Groundwater & Wastewater Services
Septic Project File & Data Review Worksheet

GWS File #: 7617B WASPS App #: 3226

Attached is a proposed design for a PPBPS Septic System with low pressure distribution for a 6 bedroom single family residence on Lot # 46 in ABERSHAM Subdivision, Mecklenburg County, North Carolina.

GWS Septic System Design Review

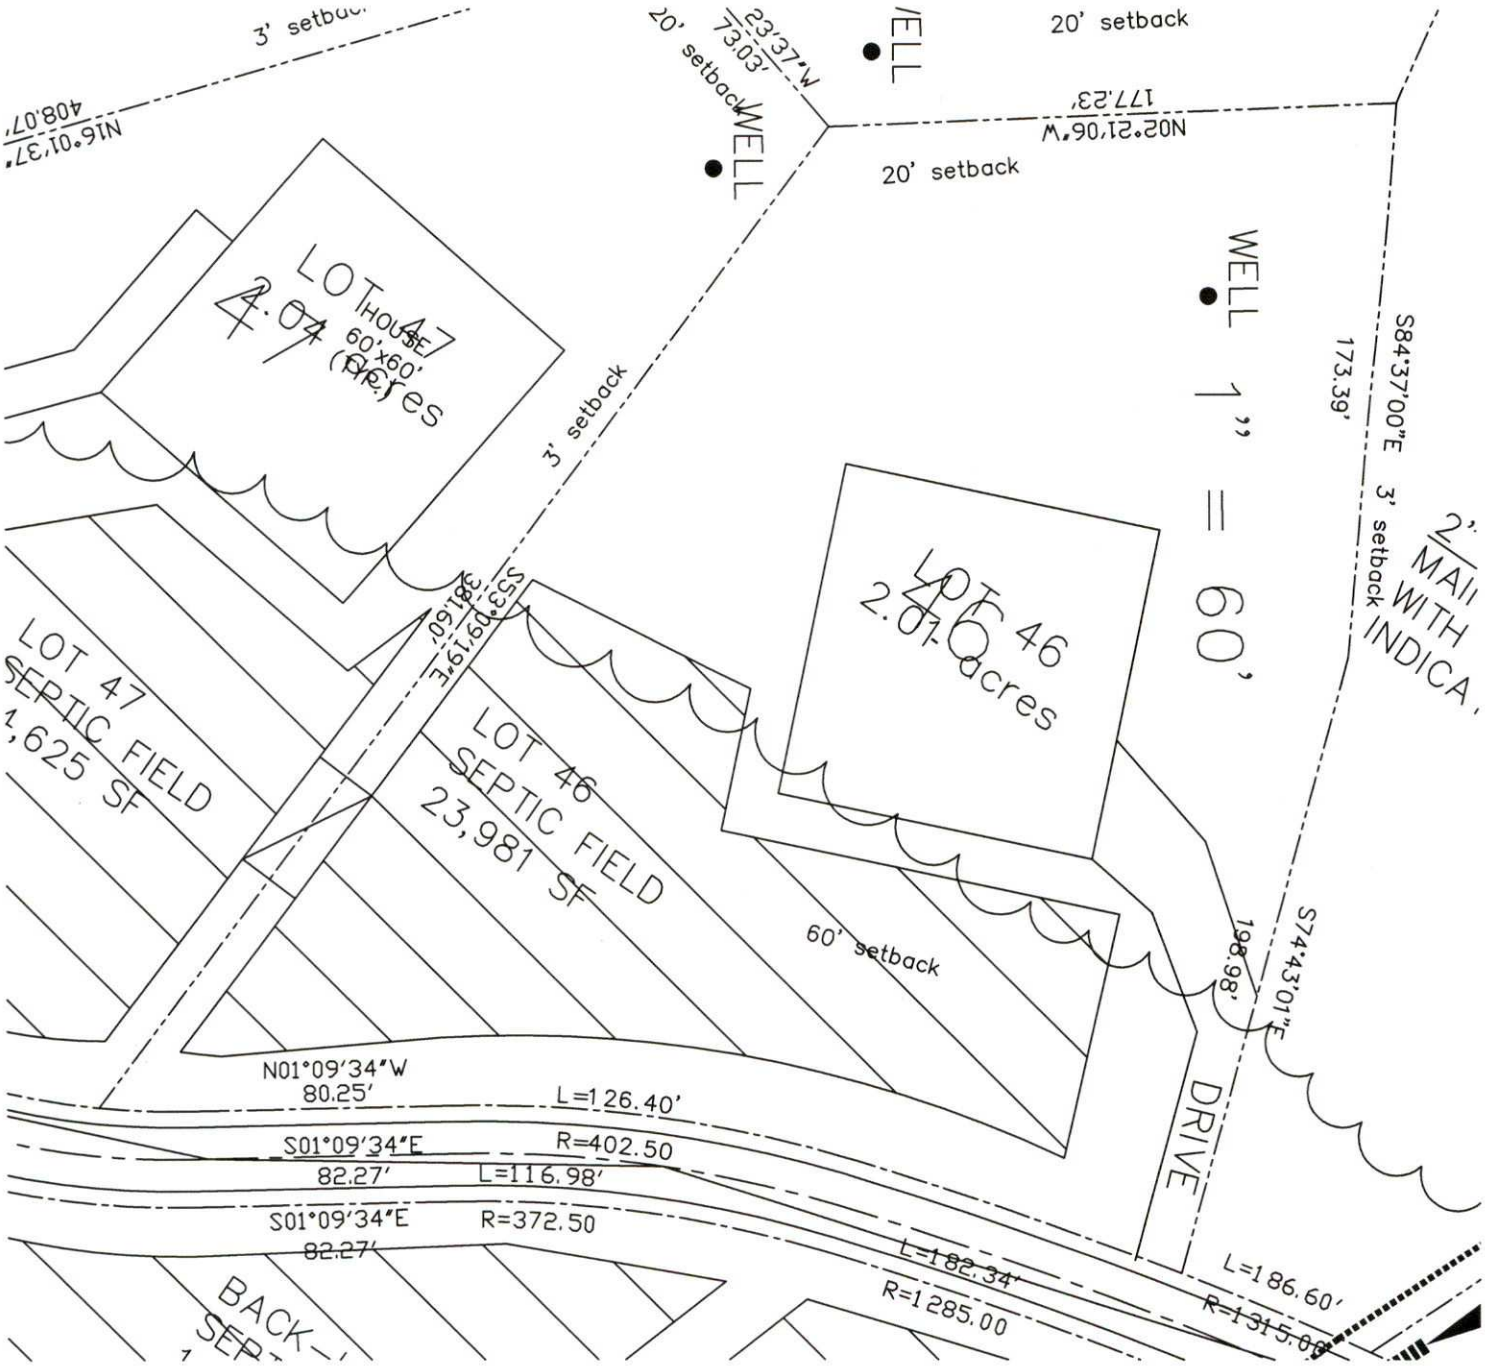
Comments: System too close to basement ? 25'
